DOE RESPONSES TO WVDP PHASE 1 DECOMMISSIONING PLAN RAIS

Figure 6-1. Unit Remediation Costs vs. Monetary Discount Rate

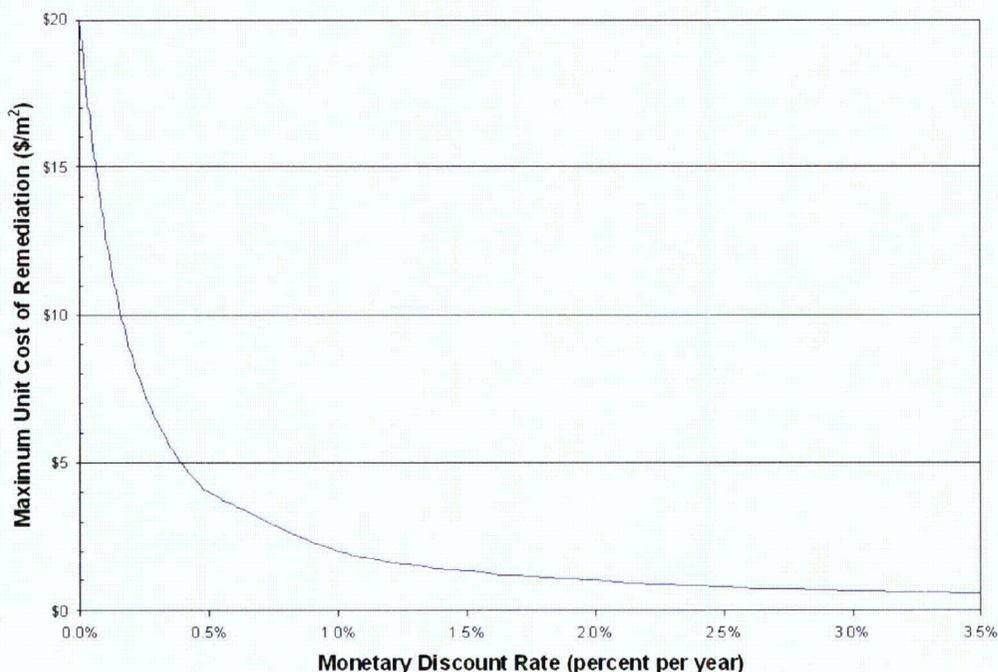
RAI: Calculations of costs and benefits for ALARA analyses: Provide either an evaluation using zero discount rate or a sensitivity analysis of the discount rate for the present worth calculations for the value of future dose averted. (Section 6.3, Page 6-5):

DOE Response: A new Subsection 6.3.6 will be added to address intergenerational concerns, with the results of a preliminary ALARA analysis using no discounting. Information will be added to Section 6.4 also to address intergenerational concerns.

Figure 6-1 shows the unit cost of remediation (C_{TU}) as a function of the discount rate. It shows that with a discount rate of zero, the cost of remediation would be approximately \$20/m². Because this unit cost is less than the \$36.38/m² disposal component of the total remediation cost in the preliminary analysis (Section 6.3.3), the DCGLs result in intergenerational doses that are ALARA and further remediation would not be necessary.

Figure DC1-1. Sheet Piling Supporting the Fuel Storage Pool Excavation Looking to the West

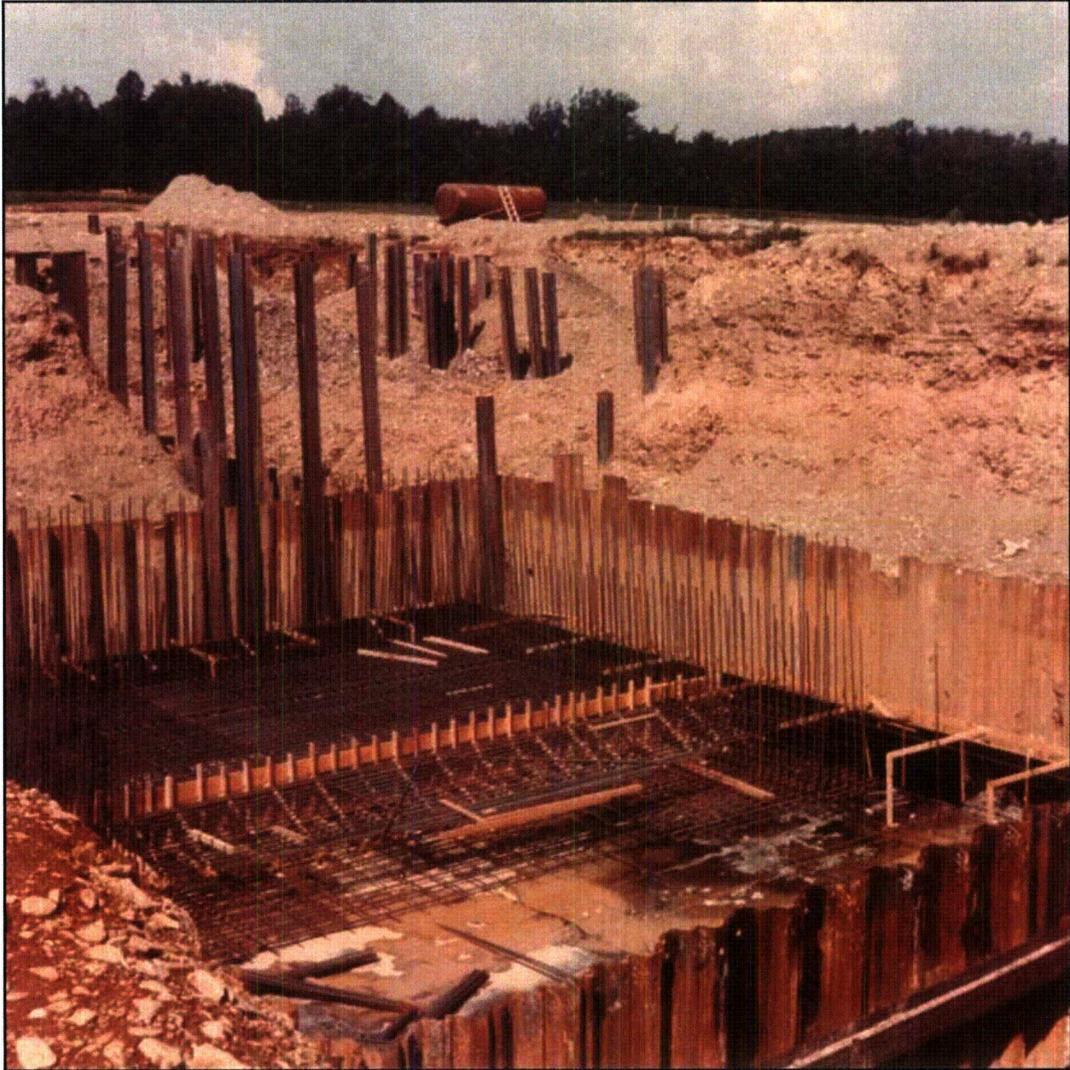
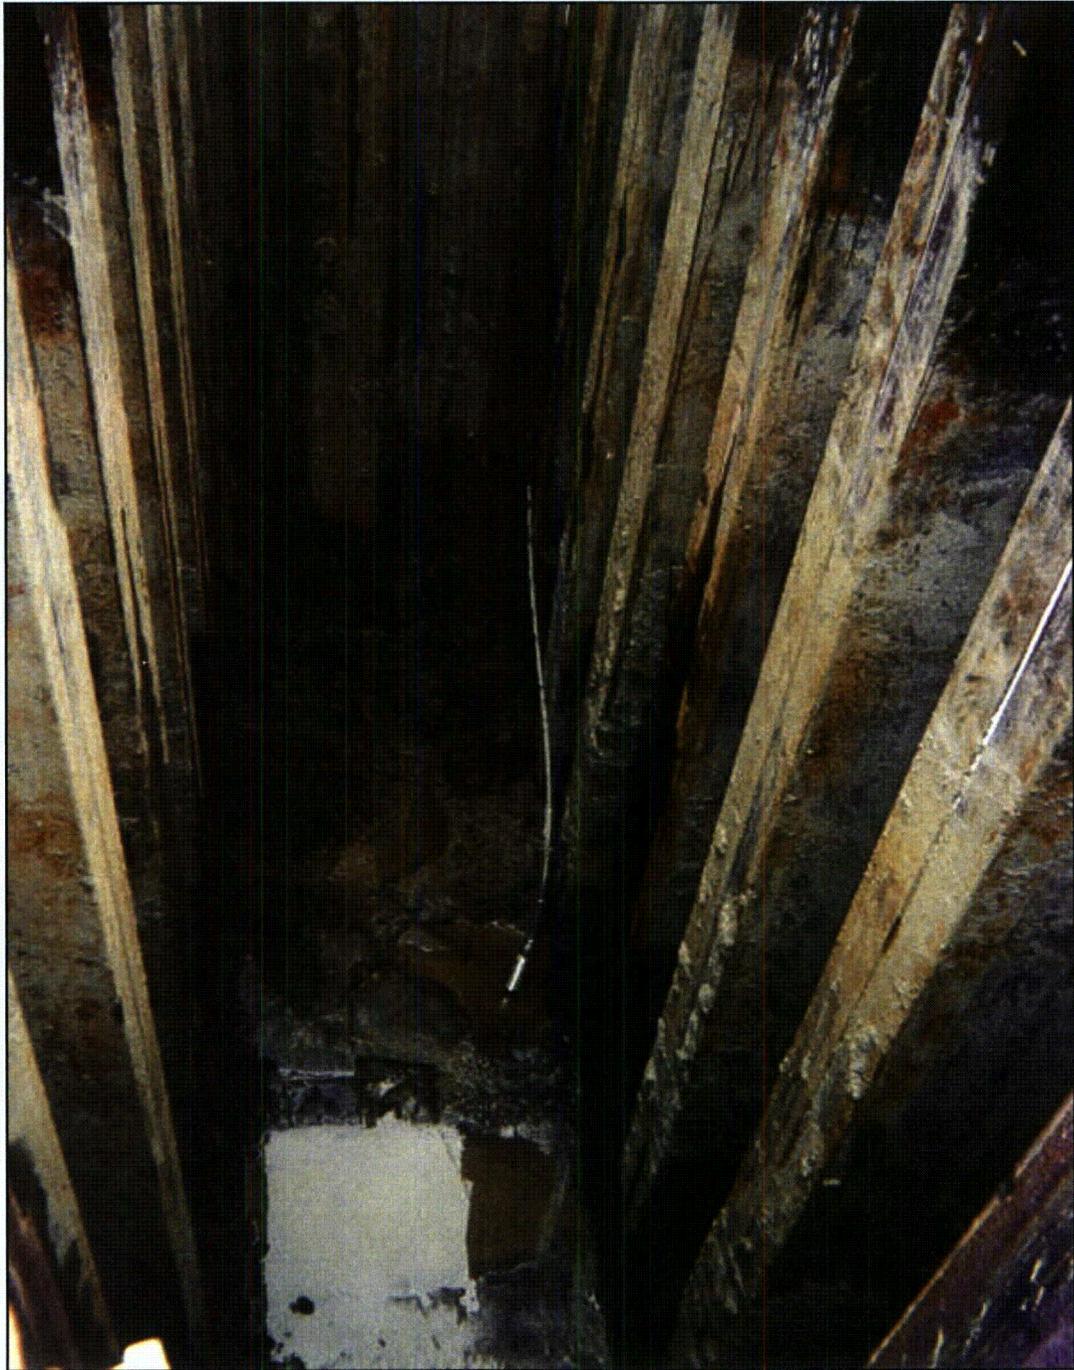
RAI: Section 7.4.3 states that before soil excavation takes place groundwater extraction wells will be installed and placed in operation to dewater the excavation. Details of the dewatering design were not provided in the DP. It is also not clear in Section 7.4.3 how the planned hydraulic barriers will prevent infiltration of upgradient groundwater into the WMA 2 excavation or how excess water will be managed. (Section 7.3.8, Page 7-25; Section 7.4.3, Page 7-32)

Basis: The total depth of the planned excavation for WMA 1 is approximately 13.5 m (45 ft), with more than half of the excavation below the water table. Groundwater will continue entering the excavation from below the sheet pile in the upgradient direction. Information on the amount of water to be pumped will help determine the number of wells and need of potential water treatment equipment/facility.

DOE expects that groundwater in the two large excavations can be effectively managed using conventional methods. Photographs taken during excavation and construction of subgrade cells in the Process Building and the waste tank farm excavation, some of which did not use sheet piling, suggest that this will be the case. See Figure 7C1-1. Also see Figures DC1-1 and DC1-2 with the response to RAI DC1.

Interlocking sheet piling was used during the construction of the Nuclear Fuel Services (NFS) fuel reprocessing facility in the early 1960's and by the WVDP during the installation of the pilot-scale permeable treatment wall in 1999. Photographs taken during the construction of the NFS Fuel Receiving and Storage show that interlocking sheet piling was used to support the excavation and construction of the Fuel Receiving and Storage Fuel Storage Pool (Figure DC1-1) and Cask Unloading Pool (Figure DC1-2). The sheet piling was used to support the excavation of the sand and gravel unit to a depth of 30 feet for the Fuel Storage Pool, and to a depth of 50 feet for the Cask Unloading Pool which extends into the Lavery till, an impermeable clay-rich glacial till which underlies the sand and gravel unit. The lack of water in the bottom of the Fuel Receiving and Storage excavations suggests the sheet piling was effective in preventing groundwater infiltration into the excavations.

However, sheet piling was not used to support the excavations needed for the construction of other prominent NFS sub-grade facilities such as Tanks 8D-1 and 8D-2 in WMA 3 and the General Purpose Cell and its associated operating aisle and crane rooms in the Main Plant Process Building. Photographs of the construction of Tanks 8D-1 and 8D-2 show a large deep excavation through the sand and gravel unit into the unweathered Lavery till with sloping cutback walls extending some distance away from the bottom of the excavation (See Figures DC1-6 and DC1-7). There is no indication that sheet piling was used to support the excavation. Infiltration of groundwater does not appear to have been a problem during their construction as the floor of the vault excavations appear to be dry. A portable pump may have been present at the bottom of the excavation with discharge hoses leading out of the excavation towards Quarry Creek (Figure DC1-7).

A photograph showing the driving of foundation piles in the General Purpose Cell excavation (Figure DC1-8) does not indicate that sheet piling was used to support this excavation which was approximately 35 feet deep. Infiltration of groundwater does not appear to have been a problem as the bottom of the excavation surrounding the pile driving crane appears dry.
